**Advanced Passive 1000 (AP1000)
Generic Technical Specification Traveler (GTST)**

Title: Changes Related to LCO 3.7.6, Main Control Room Emergency Habitability System (VES)

Figure B 3.7.6-12 (page 1 of 1)
Compressed Air Storage Tanks Minimum Volume

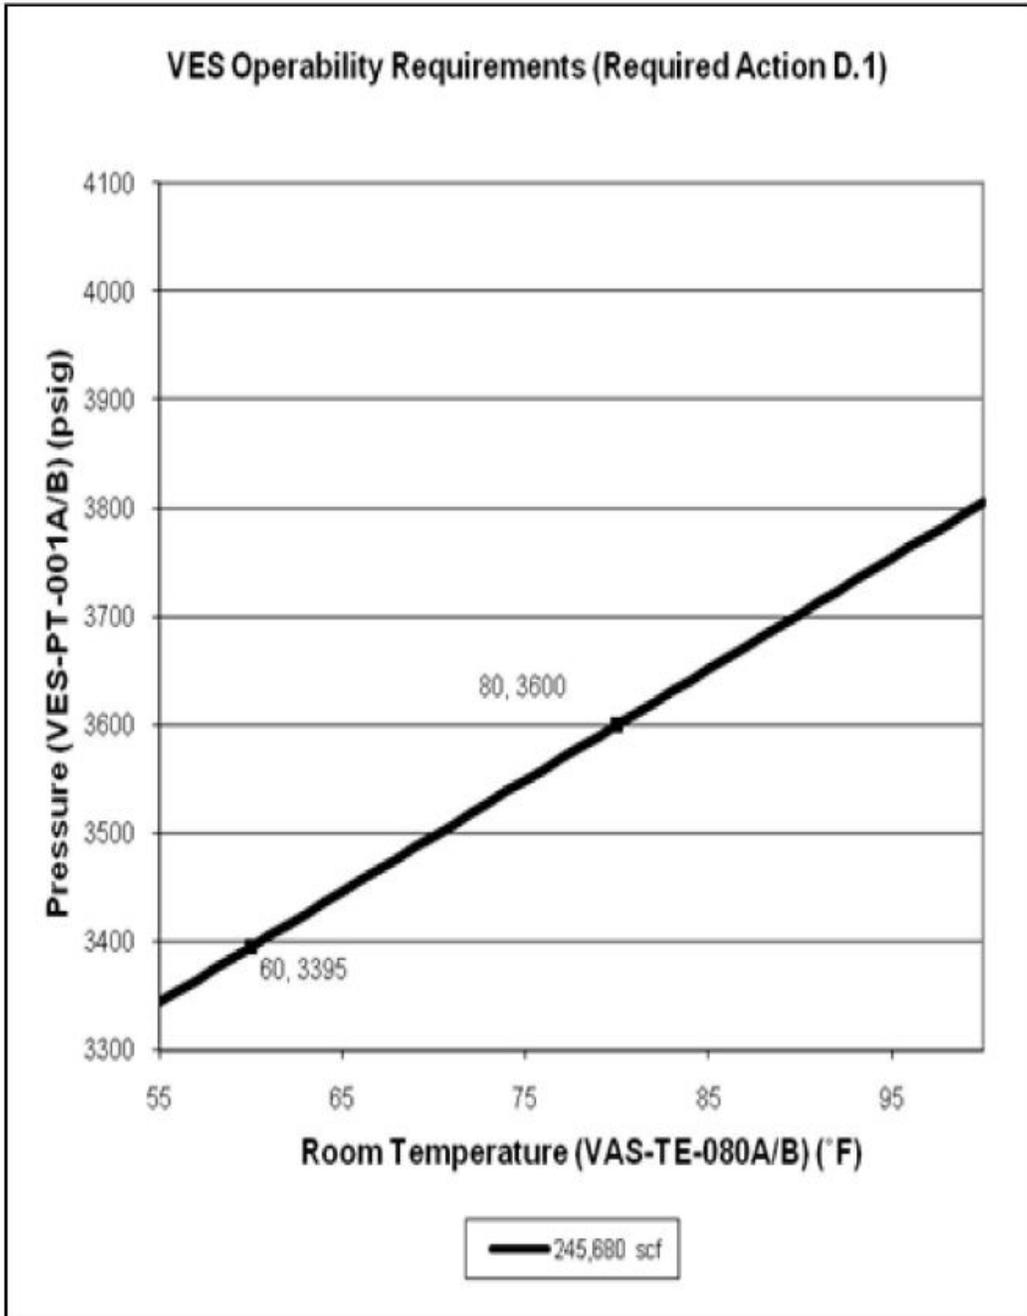
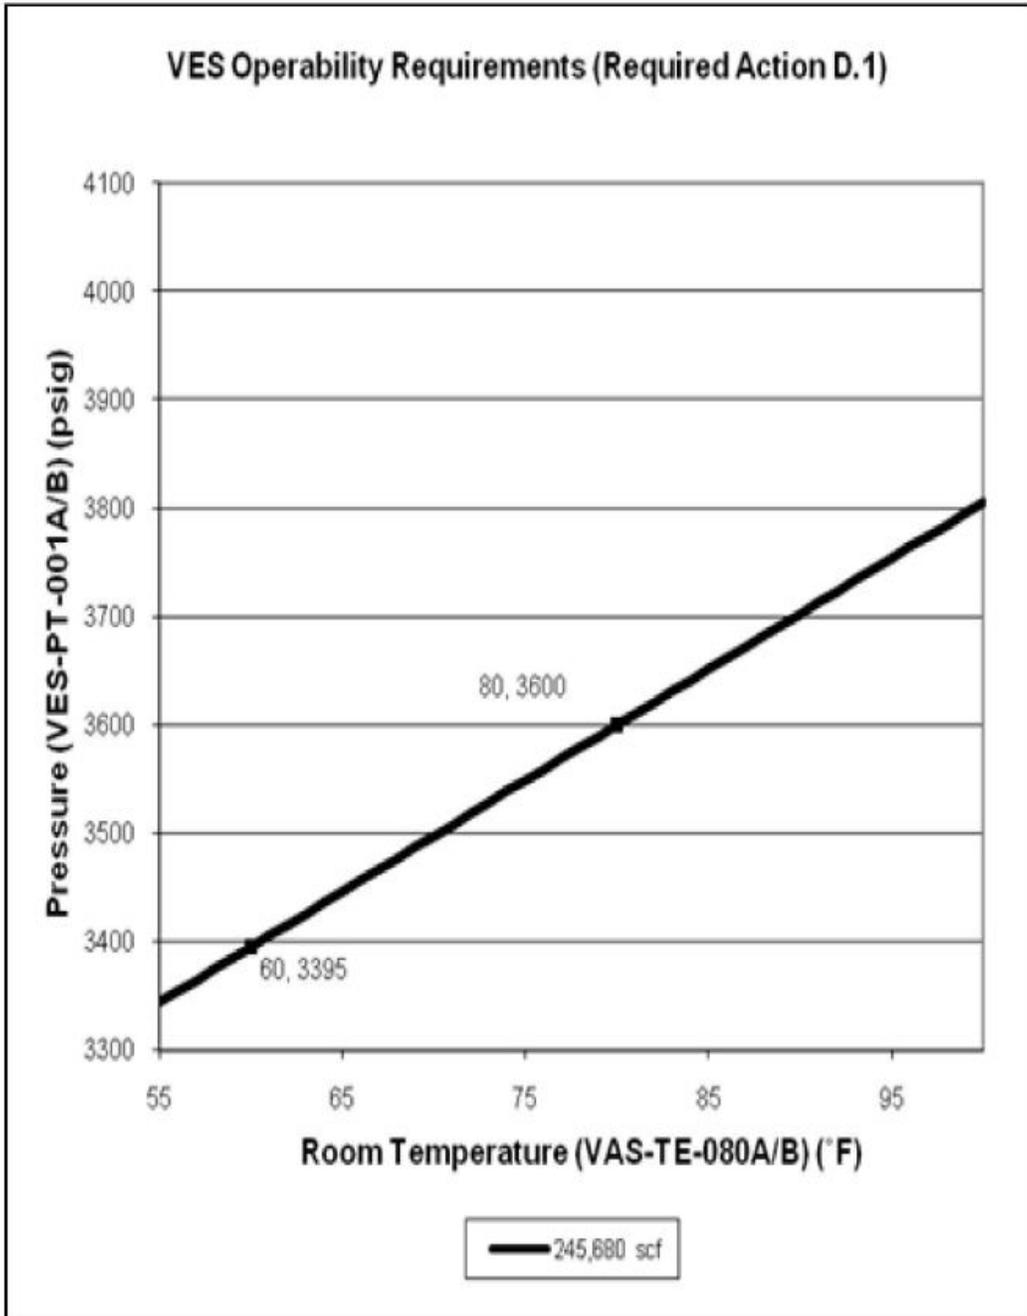
Figure B 3.7.6-2 is updated and renumbered as Figure B 3.7.6-1, and Figure B 3.7.6-2 is updated and renumbered as Figure B 3.7.6-1. (APOG Comment)

13. (Internal # 422 and 423) Revise TS Bases Figures B 3.7.6-1 and B 3.7.6-2 to add “Acceptable” region labels. The order of the Figures is swapped to align with Writer’s Guide convention. This is resolved by making the recommended change.
